**Final Remedial Investigation Report
Volume I**

Pfohl Brothers Landfill

**Cheektowaga, New York
Site Number 9-15-043**

ERRATA TO DRAFT REMEDIAL INVESTIGATION REPORT
FOR PFOHL BROTHERS LANDFILL RI/FS

Figure 3-8

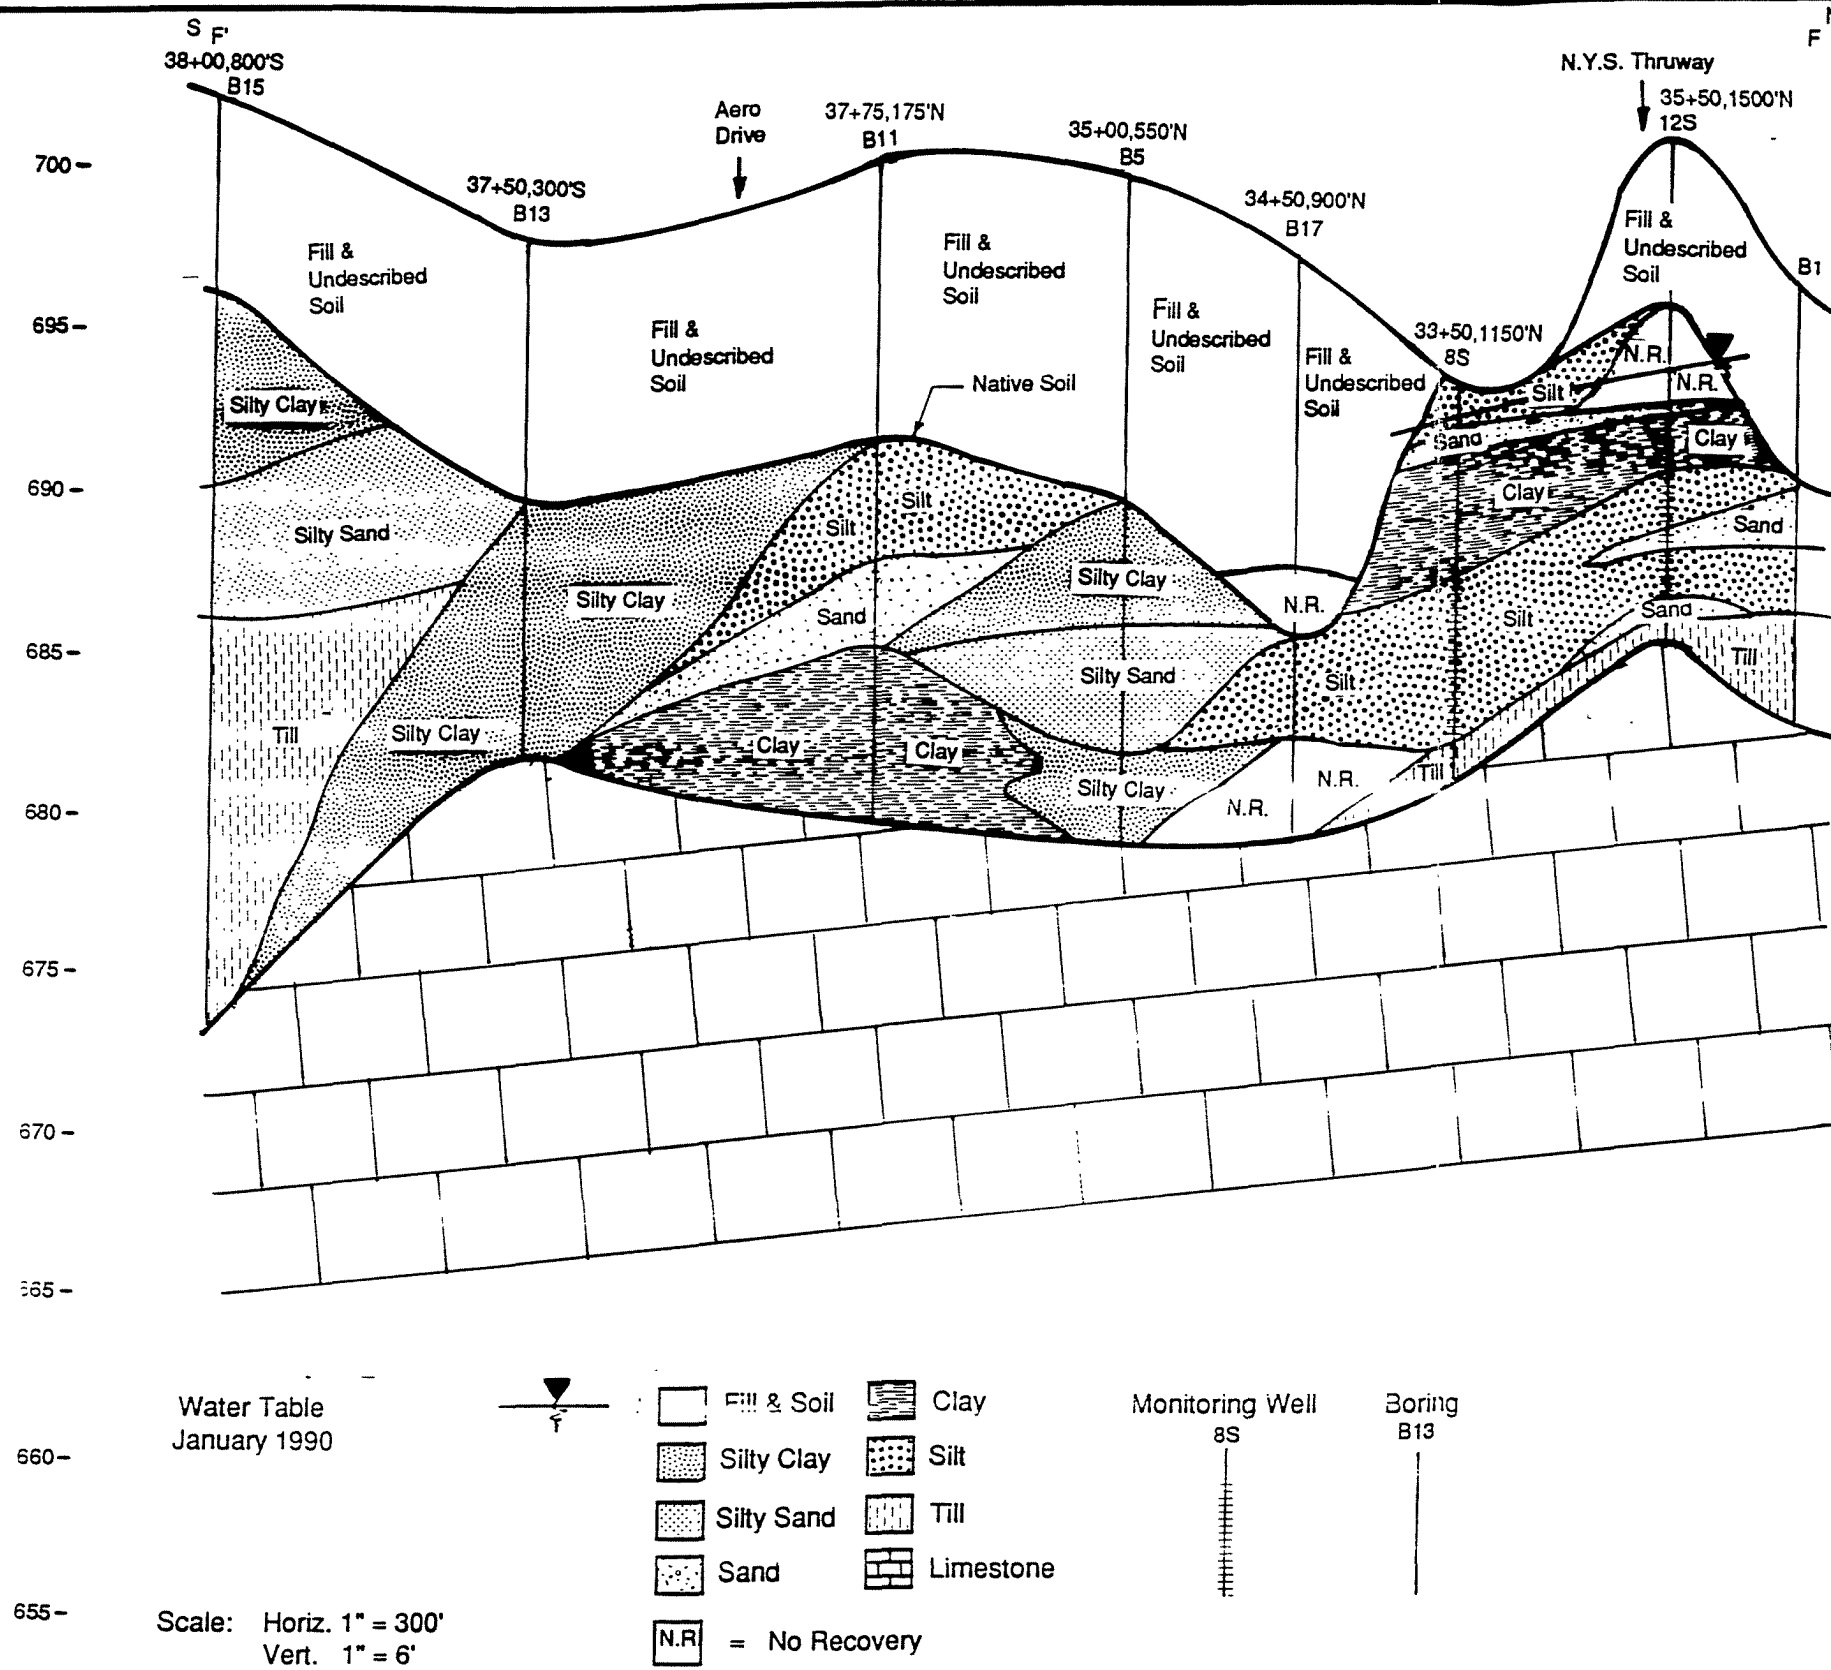
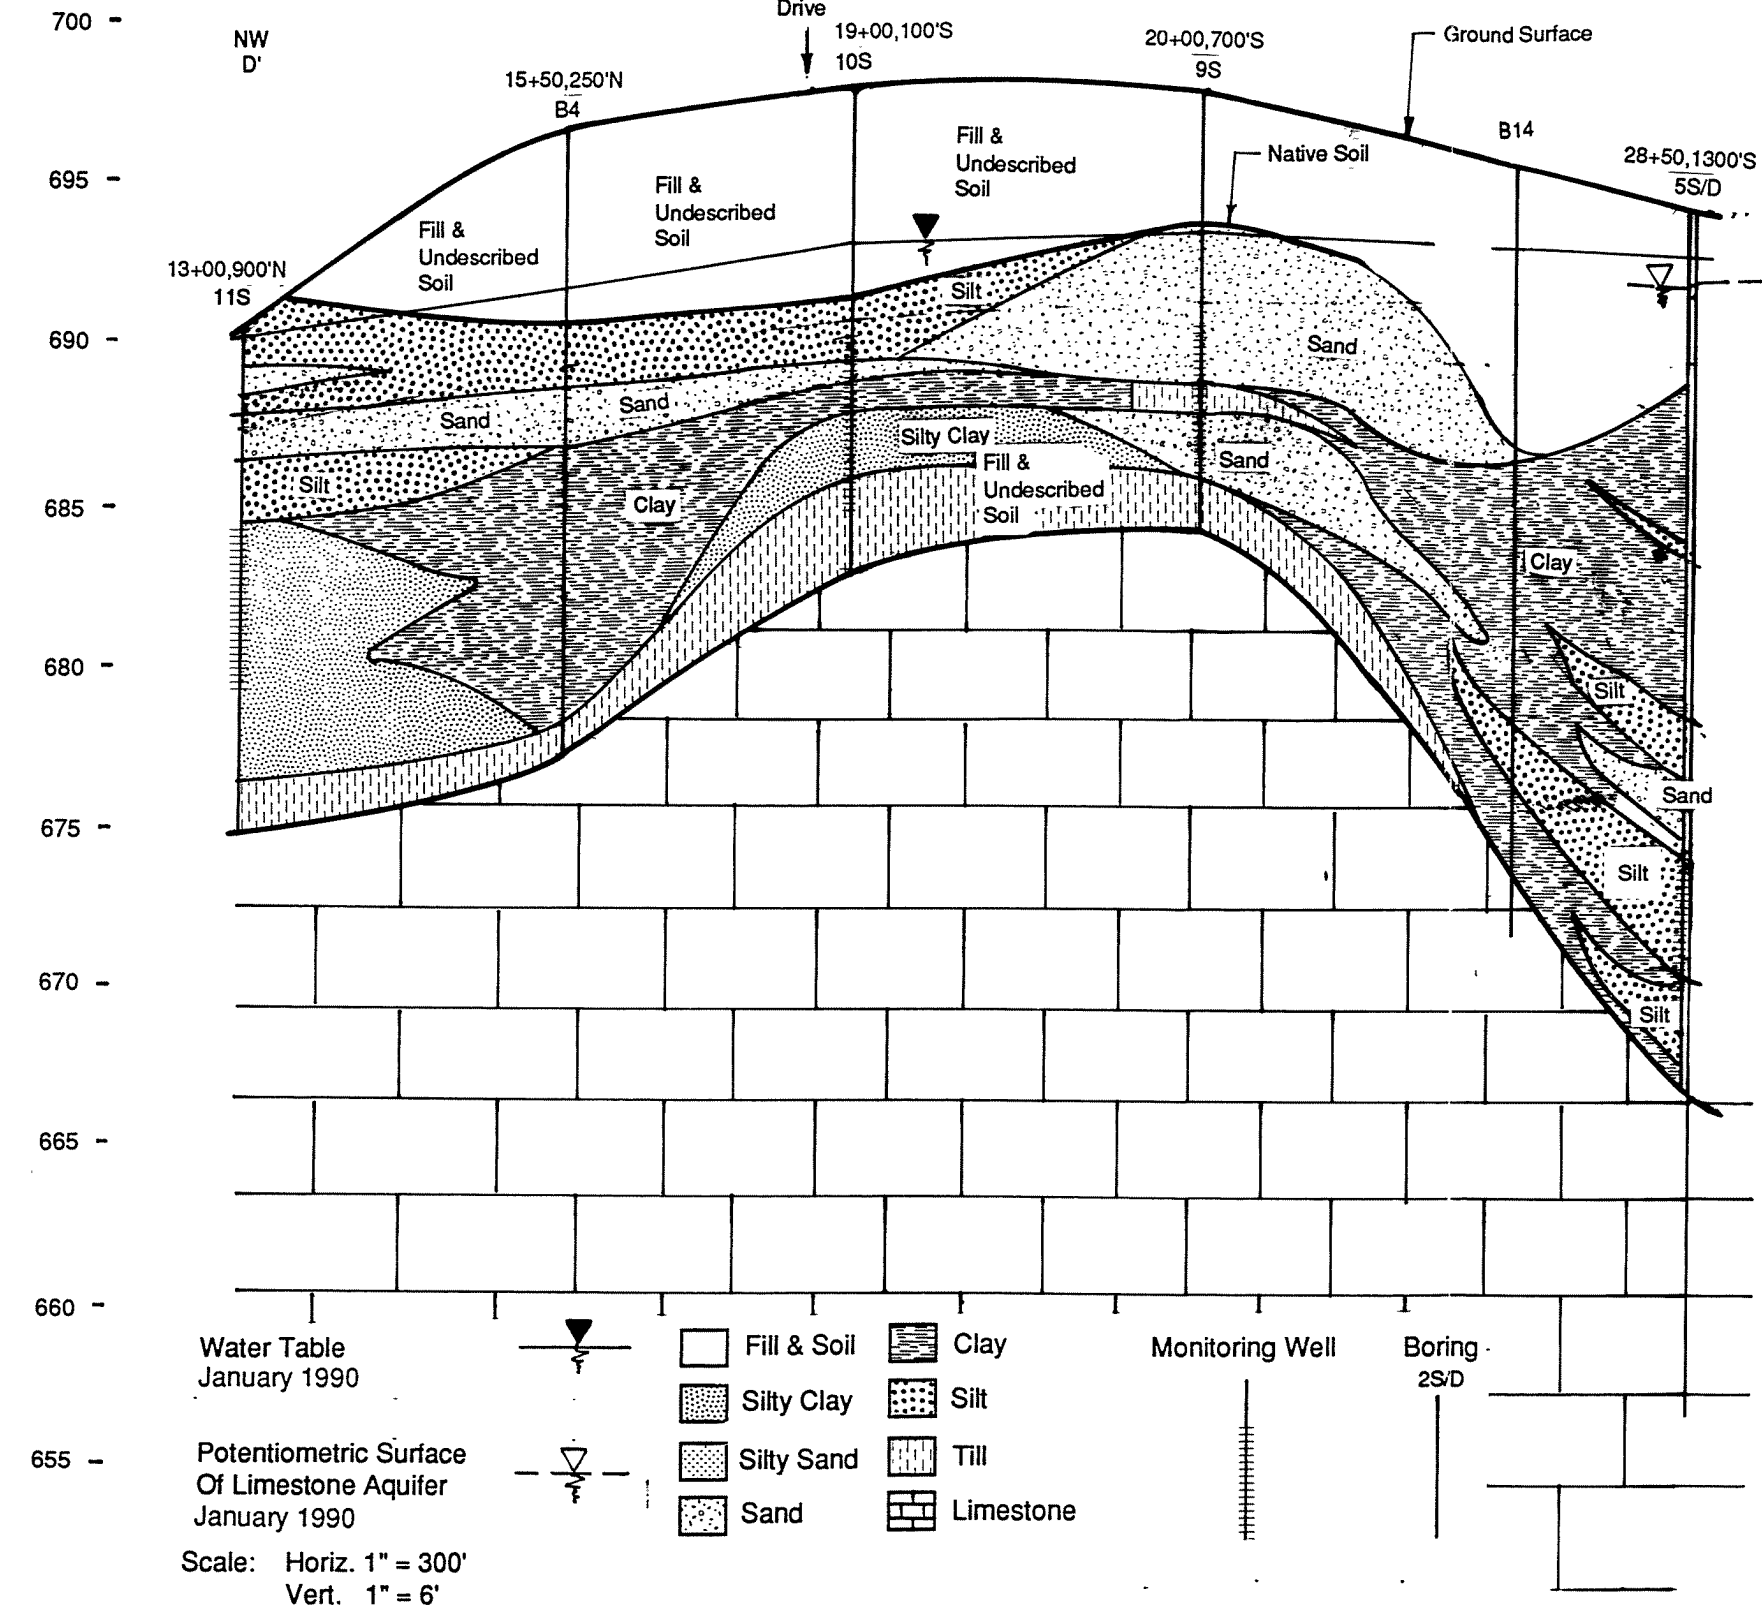
12. Figure 3-8 has been revised to include B-14. The clay unit in 9S presented in Figure 3-8 has been replaced with till.
13. Figure 3-10 has been revised to include an interval of non-recovered material between 10 to 12 foot bgs.
